# McLaren Artura - Flywheel Ring Gear Retention Enhancement

<b>Bulletin type:</b>	Service Campaign
<b>Reference number:</b>	N/A
<b>Campaign reference:</b>	SCB 16 F 001
<b>Attention:</b>	Retailer Aftersales Managers, Retailer Service Managers, Retailer Service Advisors, Retailer Technicians, Retailer Parts Managers
<b>Affected vehicles:</b>	McLaren Artura
<b>Situation:</b>	Addition of Loctite 262 to the flywheel ring gear fixing bolts
<b>Procedure:</b>	Action affected vehicles during next annual service visit. Please refer to the information outlined in this document to complete the required work
<b>Date:</b>	10 October 2023

**Image 1** Location of flywheel ring gear bolts (1)

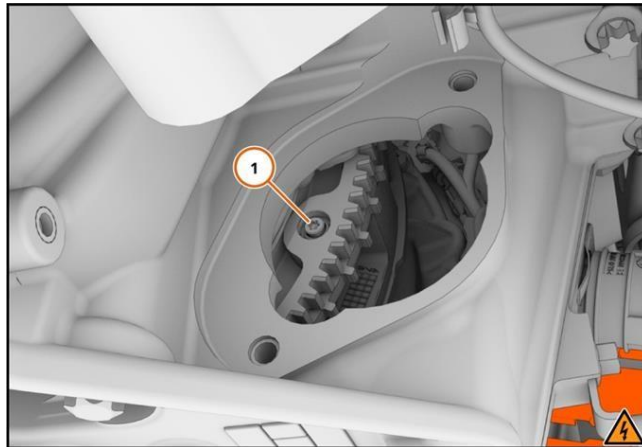
Through continuous product quality monitoring, McLaren Automotive has released an improved fixing procedure for the flywheel ring gear bolts which now includes the addition of Loctite. A rework procedure is outlined in this document. McLaren Automotive requests Retailers to carry out this rework during the next annual service visit of the vehicles affected by this campaign.

To complete this rework, Loctite 262 which can be sourced locally, is required.

The flywheel ring gear bolts should be reused.
